THE GROVE U. M. C. SUBDIVISION

APPLICATION NUMBER 8 DATE March 3, 2005
APPLICANT The Grove U.M.C. Subdivision
REQUEST Subdivision

THE GROVE U.M.C. SUBDIVISION

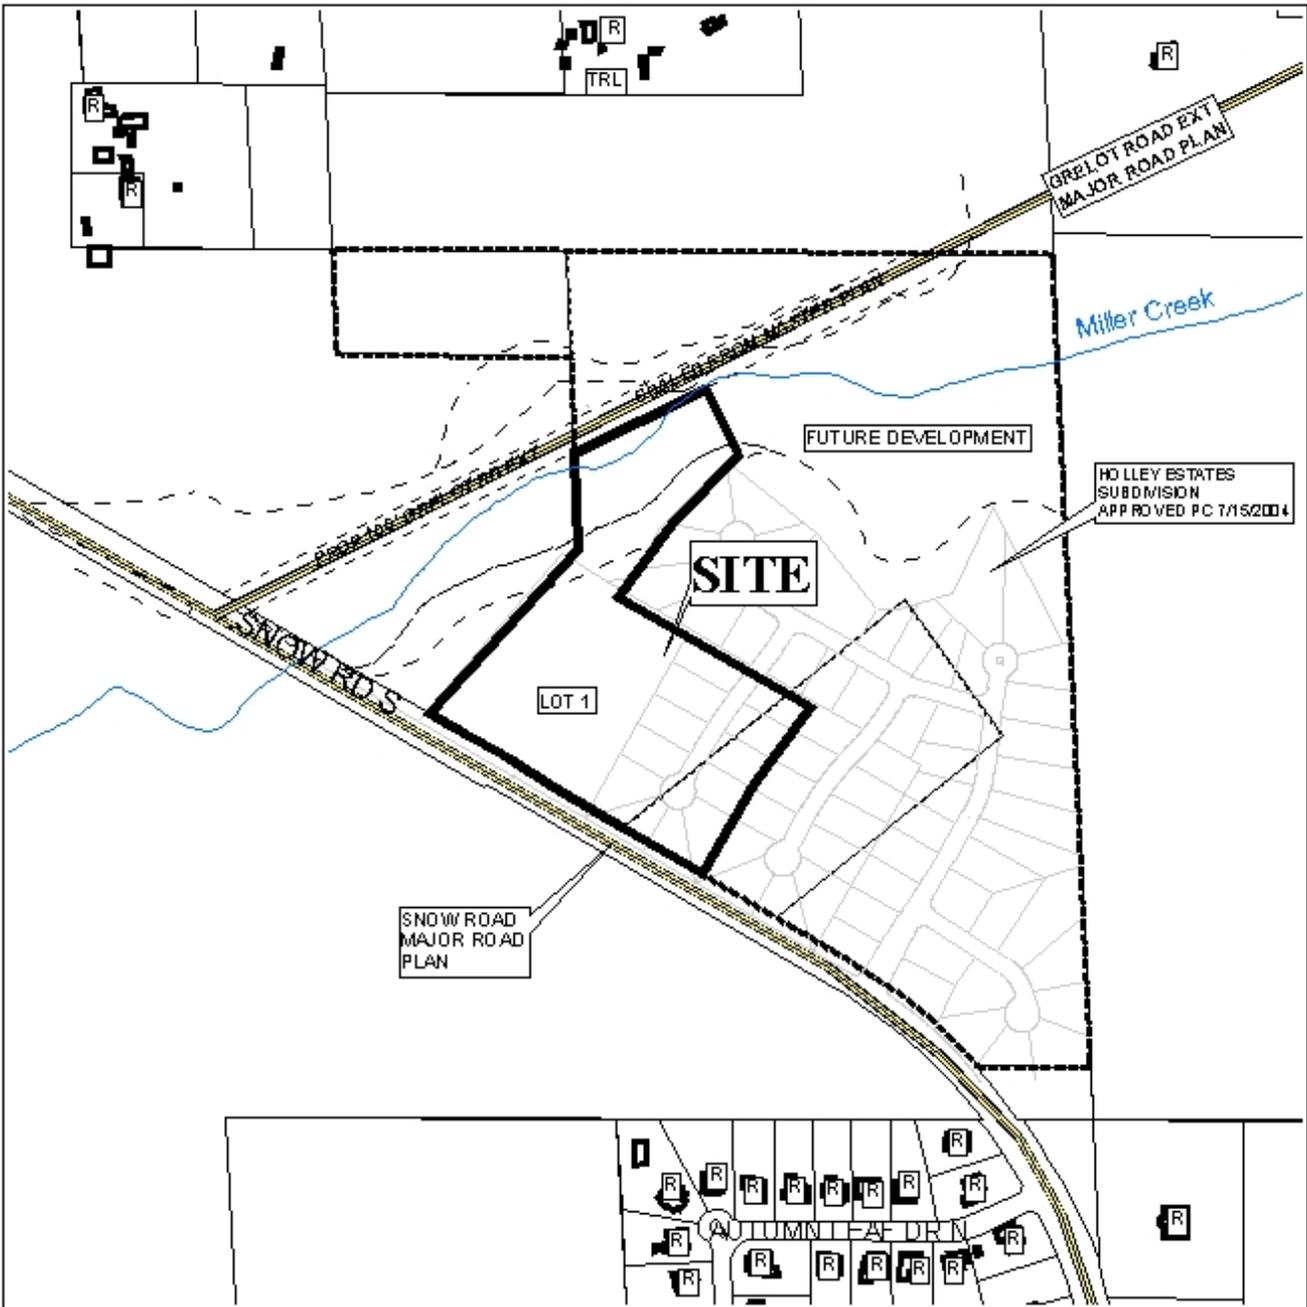
The site fronts Snow Road and the proposed Grelot Road Extension, both of which are illustrated on the Major Street Plan and require rights-of-way of 100 feet. Snow Road has an adequate existing right-of-way, but the proposed Grelot Road Extension does not; thus dedication of sufficient right-of-way to provide 50 feet from the centerline of the proposed Grelot Road Extension should be required. Additionally, access management is a concern; thus the site should be limited to two curb cuts to Grelot Road (when constructed) and three curb cuts to Snow Road.

The required 25’ minimum building setback lines are not shown, and would be required on the final plat from any dedication.

The site is located in the County; thus, should it adjoin residentially developed property, a buffer must be provided, in compliance with Section V.A.7 of the Subdivision Regulations.

The plat meets the minimum standards of the Subdivision Regulations and is recommended for Tentative Approval, subject to the following conditions: 1) the dedication of sufficient right-of-way to provide 50 feet from the centerline of the proposed Grelot Road Extension; 2) the placement of a note on the final plat indicating that the site is limited to two curb cuts to Grelot Road and three curb cuts to Snow Road; 3) the depiction of the 25’ building setback lines on the final plat from any dedication; and 4) the placement of a note on the final plat stating that, should the site adjoin residentially developed property, a buffer must be provided, per Section V.A.7 of the Subdivision Regulations.
